STAFF REPORT

SPECIAL PERMIT APPLICATION NO. SP 2009-SU-018

APPLICANT/OWNER: New Vision Community Church, Inc.

SPECIAL PERMIT PROPOSAL: To permit a church with a private school of general education.

ROUTE 29 IMPROVEMENTS PLAN

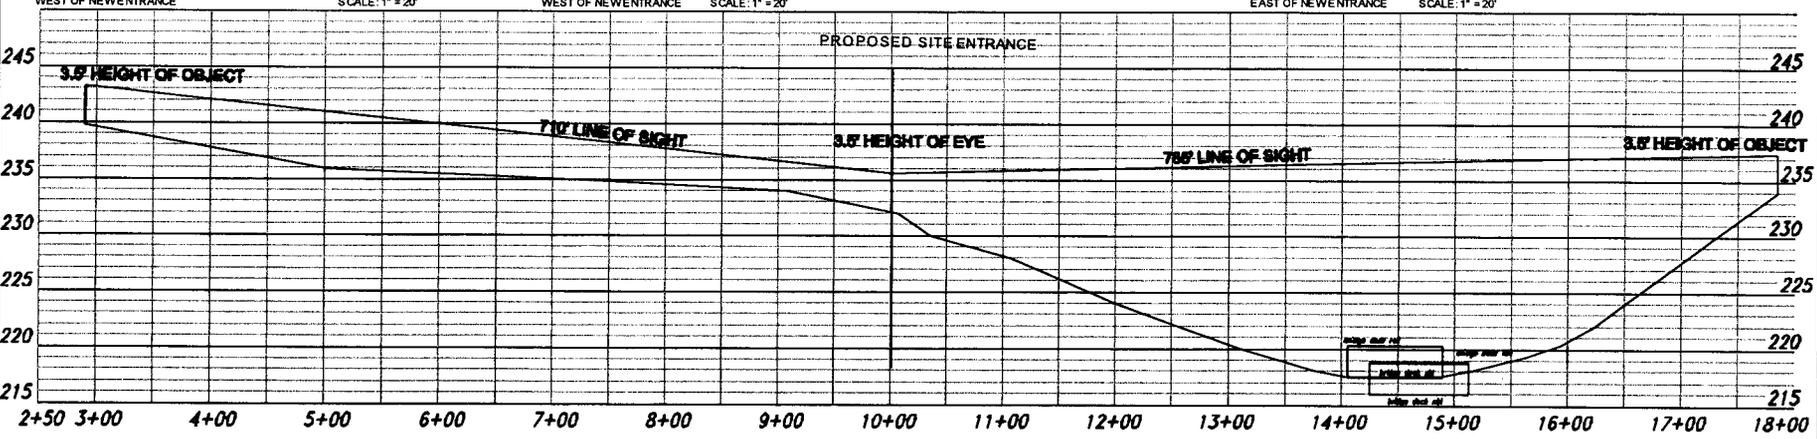
- On August 31, 2009, applicant submitted a sight distance profile as Sheet 5 of 6, as required, for a sight distance to 710 feet for the eastbound direction and 785 feet for the westbound direction. The revised plat was provided to VDOT for their review; however, adequate time has not been given for a formal review process.

- There are bike lanes on the Comprehensive Plan. The Trails Plan shows on-road bike lanes on this segment of Route 29. The applicant has failed to demonstrate how this facility will be accommodated as part of their site improvements and states that there are currently no bike lanes existing along this portion of Route 29, which if they were constructed as proposed, would end at the Cub Run bridge.
- The channelization at the entrance of the site, within the right-of-way (ROW) may not be acceptable to VDOT. In VDOT's memorandum dated August 21, 2009, they also indicate that the proposed entrance channelization island should be designed according to the Road Design Manual.

- VDOT is questioning the spacing of the median break and also the length and details of the left turn lane and the result of their review is not yet available.	The Applicant is working with VDOT on this item.
-A sight distance profile should be provided.	The Applicant has provided a sight distance profile with the enclosed revised SP Plan.
